**TOWN OF MOUNTAIN VILLAGE
REGULAR DESIGN REVIEW BOARD MEETING
THURSDAY AUGUST 1, 2019 10:00 AM
2nd FLOOR CONFERENCE ROOM, MOUNTAIN VILLAGE TOWN HALL
455 MOUNTAIN VILLAGE BLVD, MOUNTAIN VILLAGE, COLORADO
REVISED AGENDA**

3.	10:05	45	Miller	Public Hearing Quasi-Judicial	Consideration of a Design Review: Initial Architecture and Site Review Application for a new single-family residence on Lot 640BR 1, Timberview (continued from July 11, 2019)

4.	10:50	45	Miller	Public Hearing Quasi-Judicial	Consideration of a Design Review: Initial Architecture and Site Review Application for a new single-family residence on Lot 640BR-4, Timberview

UTILITY PLAN/GRADING PLAN
SCALE: 1" = 5'

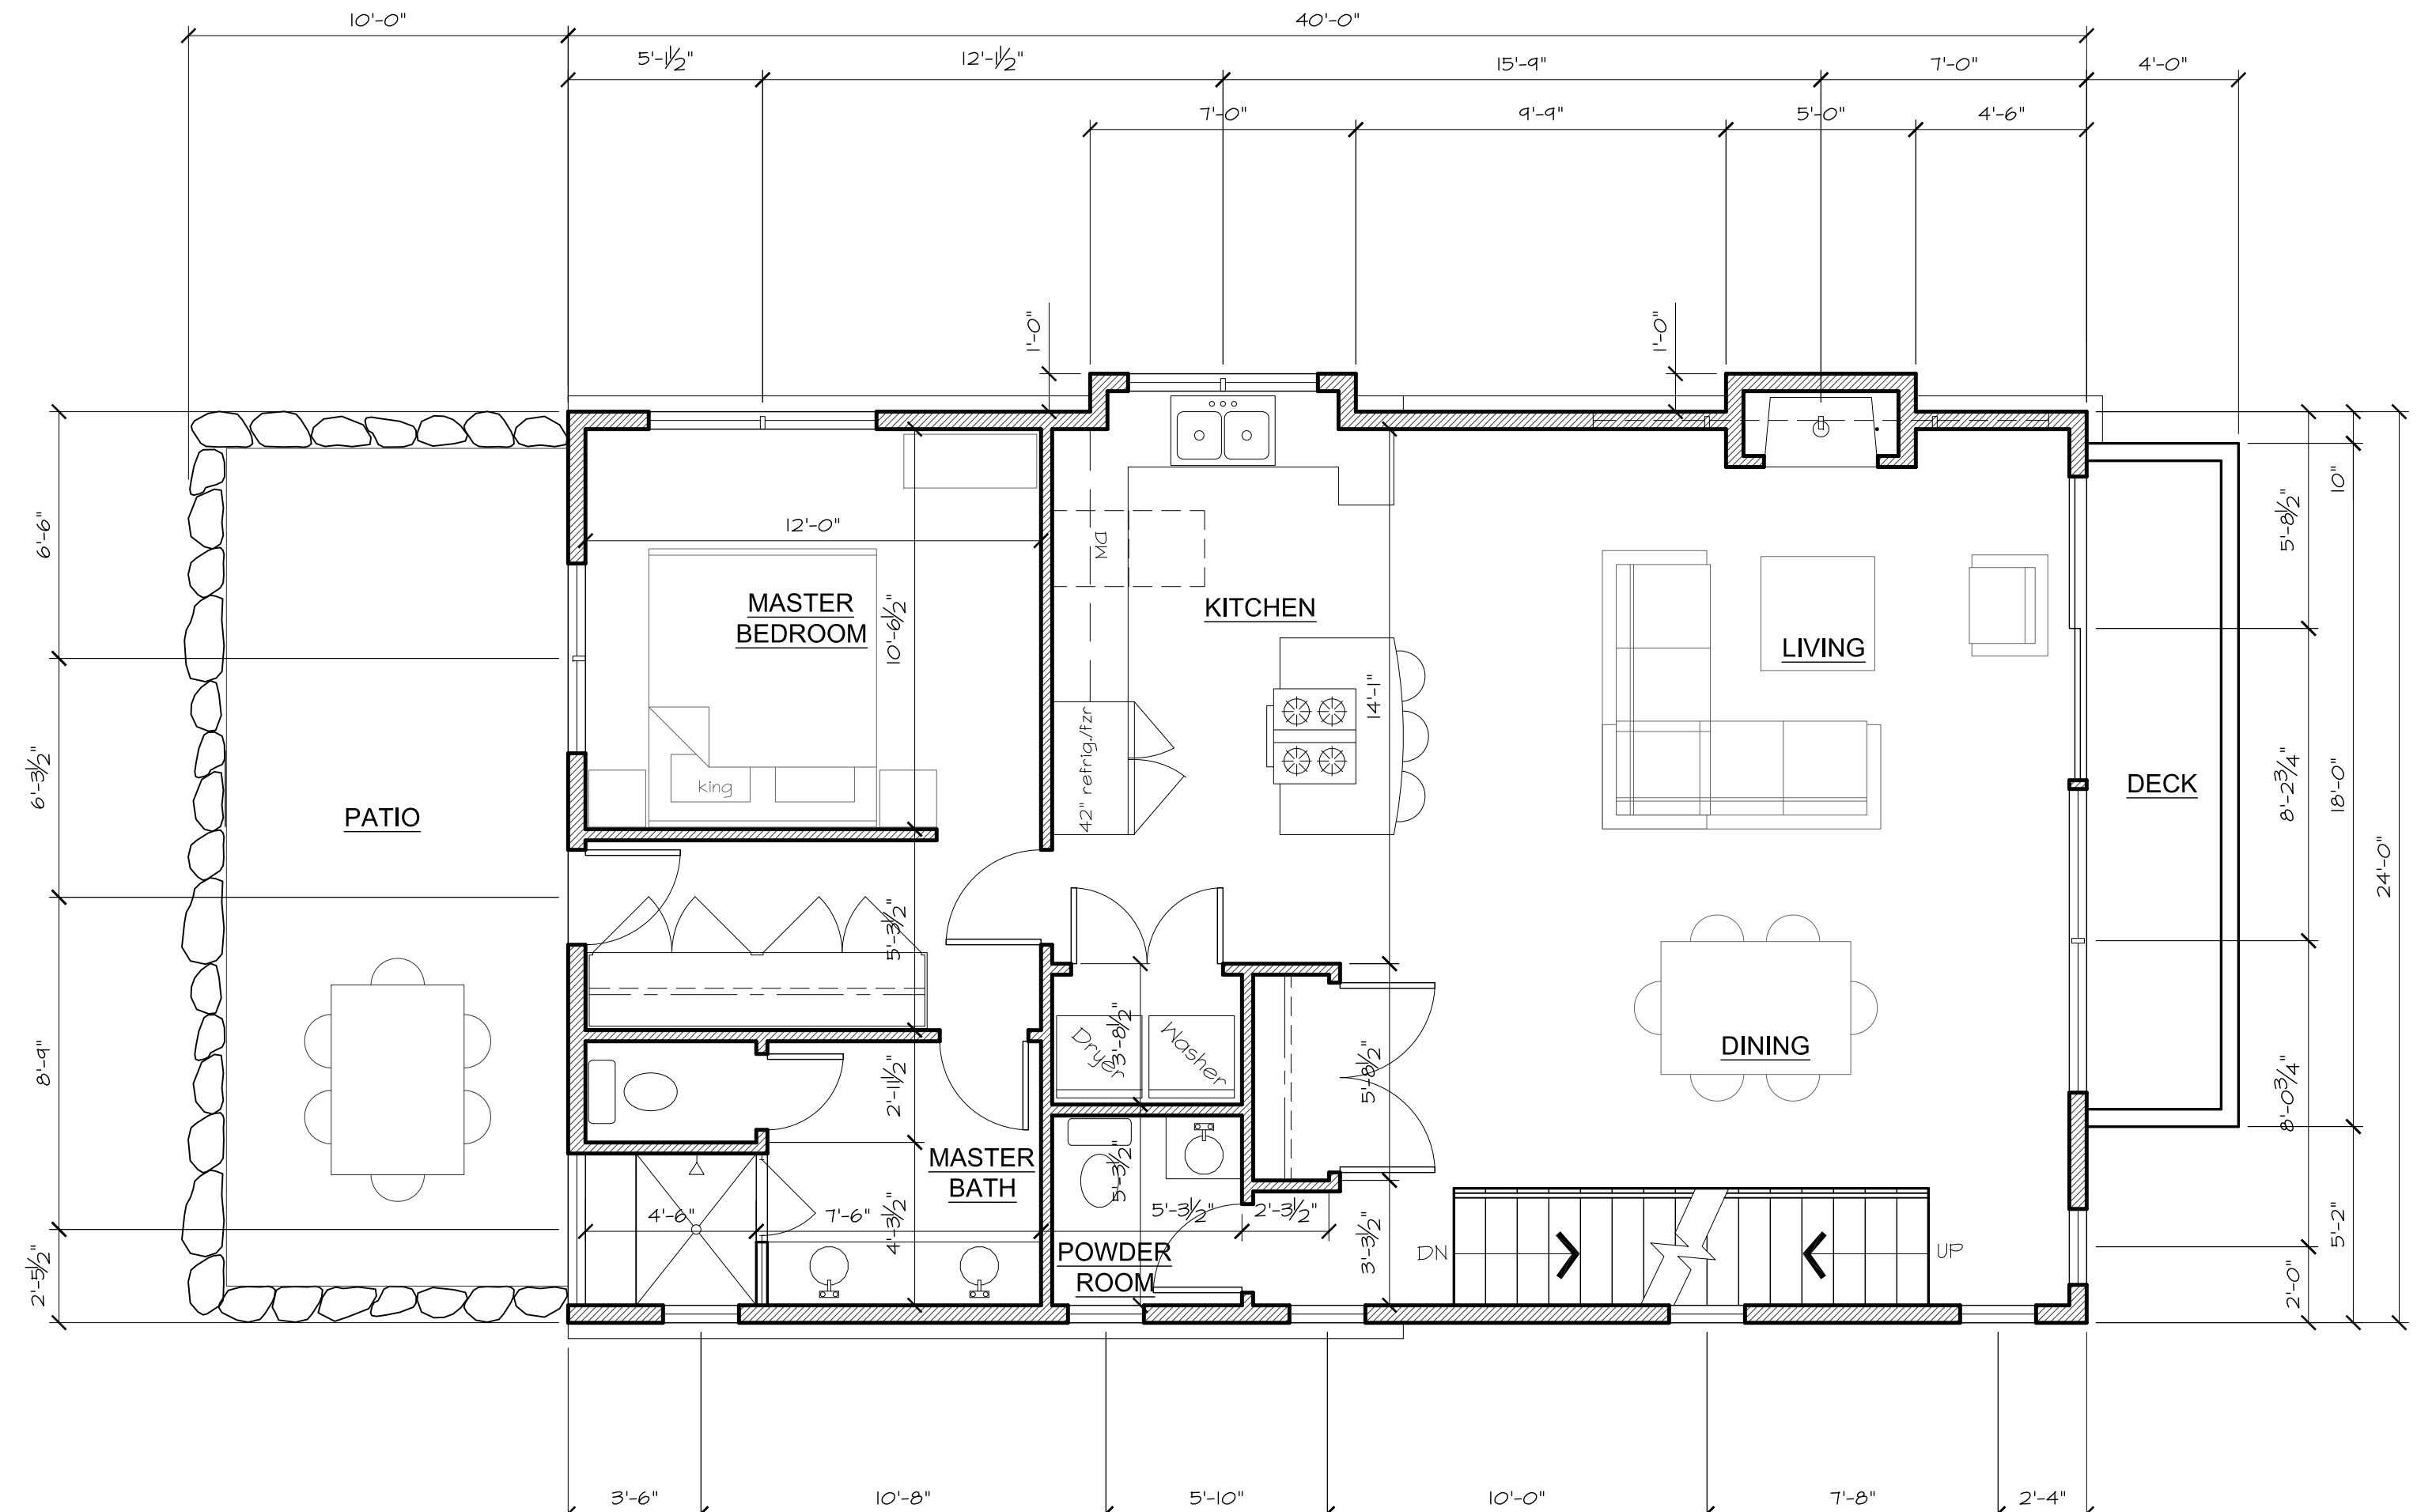
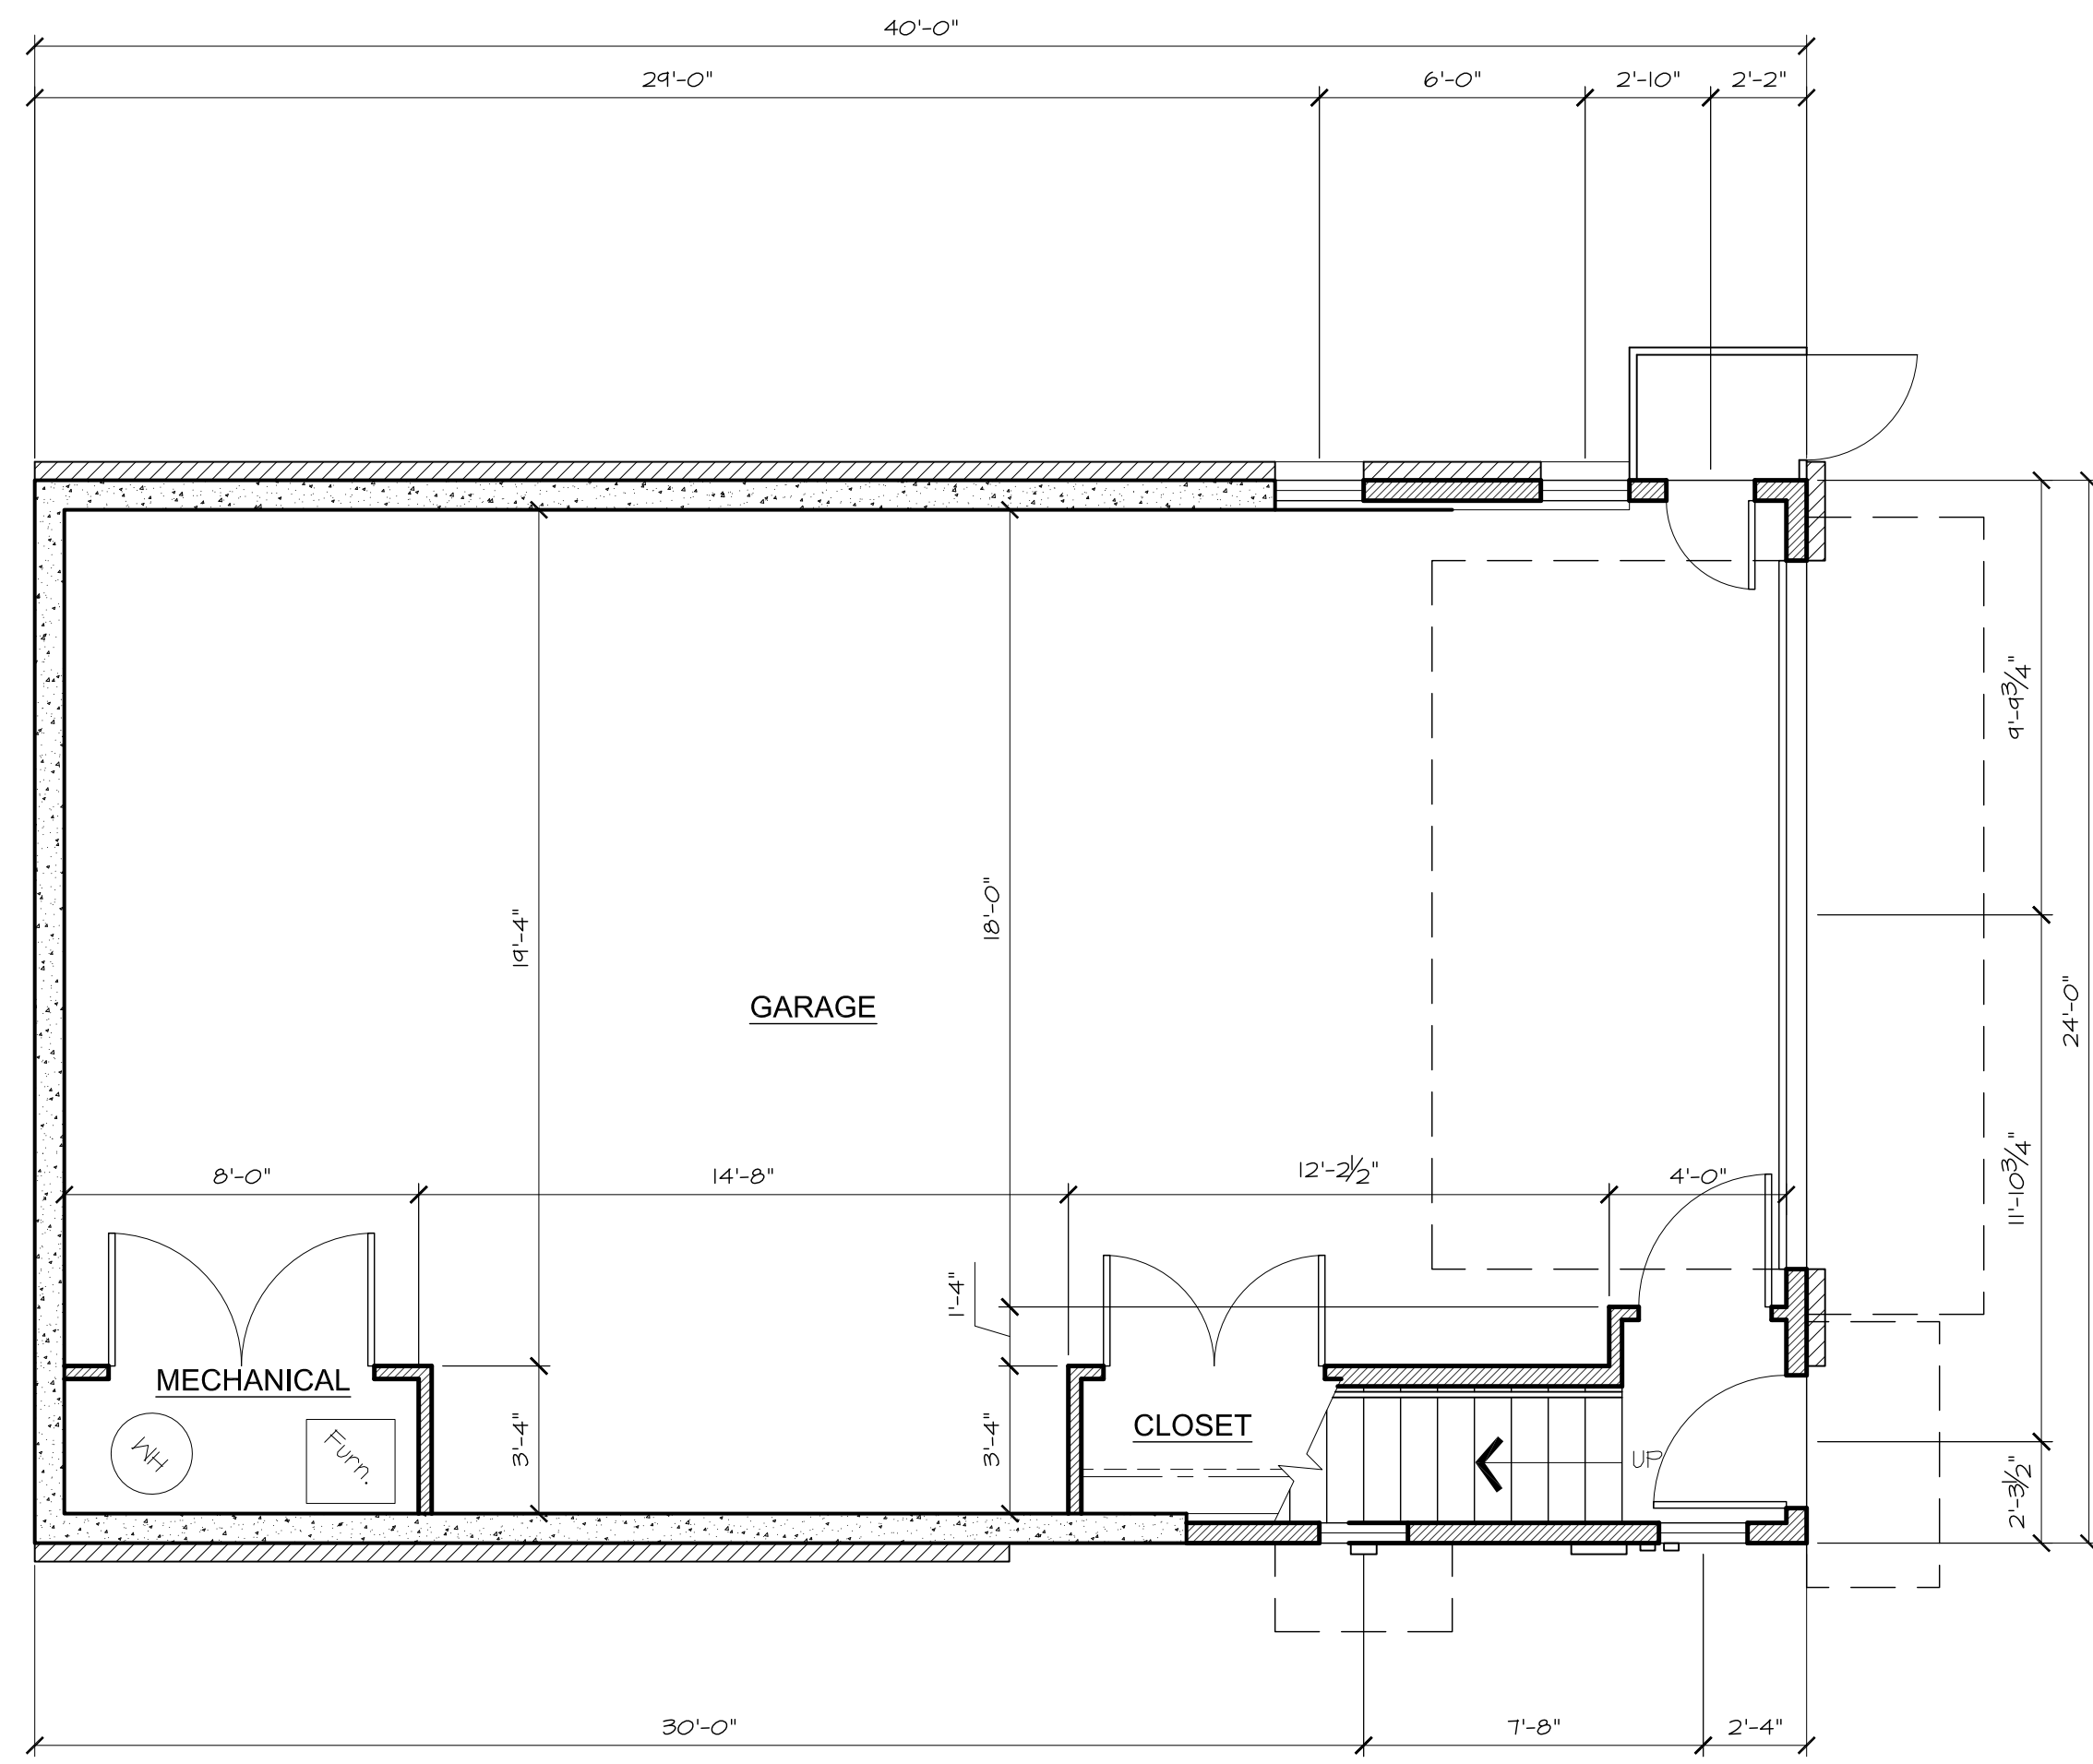
Staff: The applicant has not provided a grading and drainage plan at this time. Prior to final architecture and site review, a full grading and drainage plan shall be submitted which shall document all disturbed areas, cuts, fill, final slopes adjacent to the home, stormwater design including positive drainage from proposed home, and specifications of any retaining walls that are necessary to construct the home.

Staff: All utilities are currently located within 640BR and will not require any additional extensions within Town ROW or property. The plan set shows the proposed connection location for the project's utilities to the east of the home.

- 1) The applicant shall be required to submit an updated and finalized grading and erosion control plan detailing any retaining walls, proposed grading, stormwater mitigation techniques, material storage calculations, etc. This plan shall demonstrate how final grades adjacent to the home meet the requirements of the CDC.

- 5) Prior to the issuance of a building permit, the applicant shall field verify all utilities and submit a revised utility plan to the public works director identifying the location of utilities and connection points.
